# ORIGINATION FORM

Proposed Revisions to a Standard Plans Index  
(Please provide all information – Incomplete forms will be returned)

Index Number: 450-010  
Sheet Number (s): 2  
Index Title: Bridge Approach Expansion Joint Concrete  
Pavement

**INSERT DETAIL**

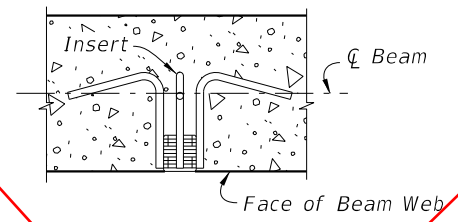
Removed Insert Detail

Intermediate diaphragms are typically not required; when required inserts for intermediate diaphragms should be shown on the shop drawings.
